**CITY OF SAINT PAUL**  
*Melvin Carter, Mayor*

**DATE:** February 14, 2020  
**TO:** Comprehensive and Neighborhood Planning Committee  
**FROM:** Mike Richardson, City Planner  
**SUBJECT:** Districts 14 and 15 Residential Design Standards Amendments

**Draft Language for Districts 14 & 15 Residential Standards**

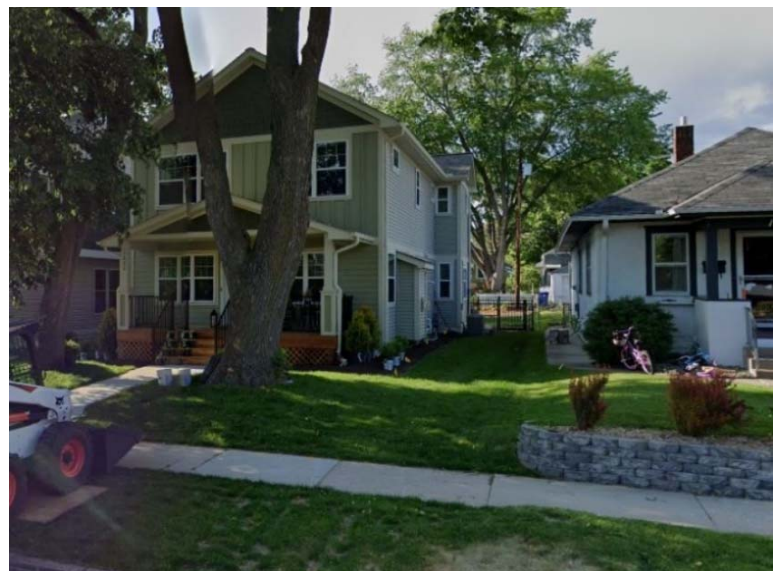
Examples: 1737 James (on the left) is an example of a foundation poured new, allowing for articulation to be integrated into the design. A variance for sidewall articulation was requested for 1946 Wellesley (right). The application was to extend the existing 27' wall pictured to an overall length of 50'. The district council recommended denial and the BZA denied the application for an articulation variance as originally proposed. This is an example of a project that the district councils would likely want to discuss. It would still require articulation (and a variance) with the recommended changes.

**Restrict applicability of height and articulation requirements to new residential construction and additions of a certain size.**

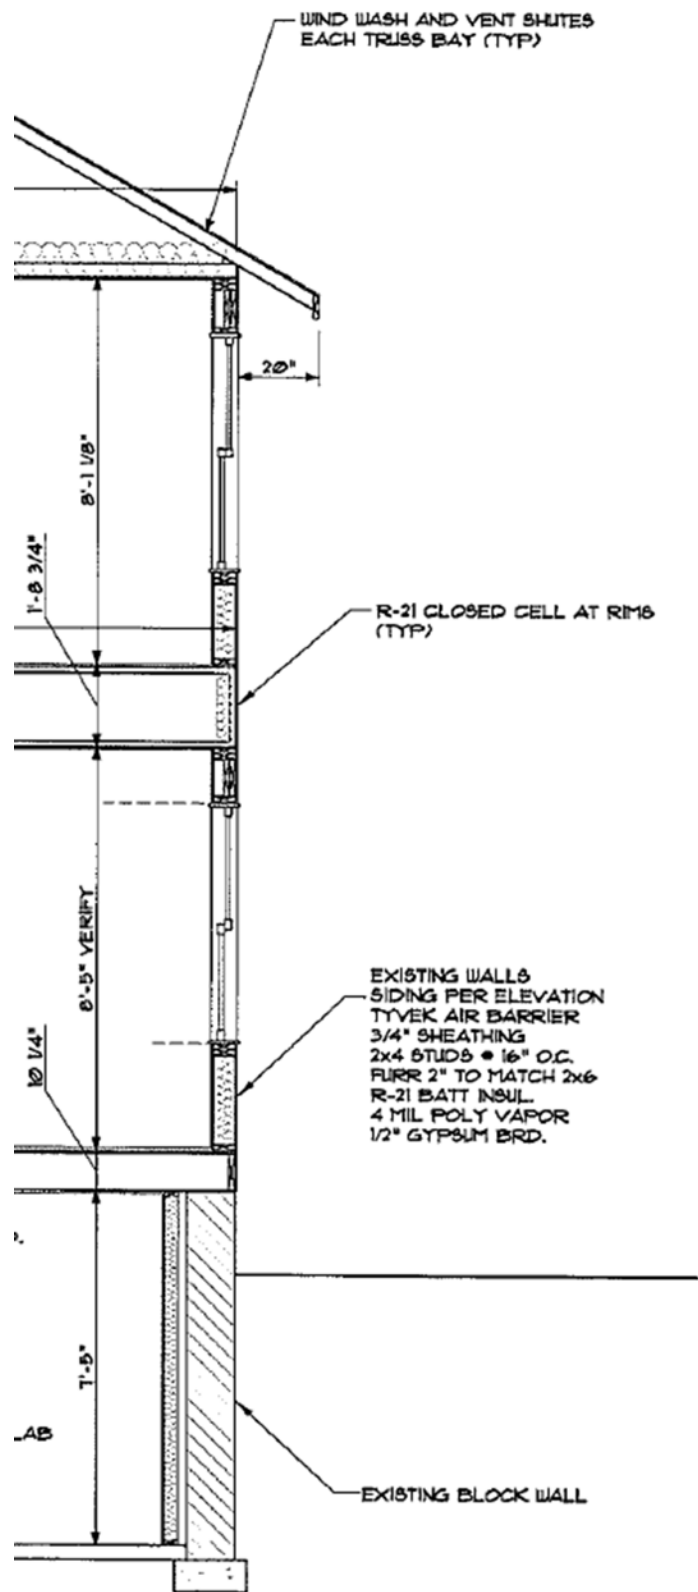
Discussion: The main factors that contribute to the height of a house are height of the foundation wall above grade, floor to ceiling height, truss/joist system height, and roof height/pitch. Each of these have reasonable minimums based on building code, design, and comfort. When added together and considered in the context of smaller side yard setbacks and lower height limits in the R4 zoning district, it is often difficult to meet the 22' height limit. One of the things that can be adjusted is the roof pitch, but that often leads to a design that is inconsistent with the roof pitches found throughout Saint Paul's housing stock.

Example: 1325 Hartford is an example for considering an increase of allowed height in R4. The application was to expand from a 1 ½ story house to a full two stories and one of the variances needed was for height. The original home was built with at 3.7' side yard setback on one side and so was fixed to need to meet the 22' building height. The cross section shows the breakdown of elements that contribute to height. 16' 7" for combined floor to ceiling height is fairly standard and seems reasonable, as does a combined 2' 7" for the truss and joist systems. With a 24' limit, this would allow 4' 10" total for both foundation wall height and the roof (measured as described in Sec. 60.203), which does not seem excessive and is still a significant reduction of height at the side setback lines as compared to the base maximum.

**Increase the R4 height limit of 22' at the setback line to be the same as in R3 at 24'.**
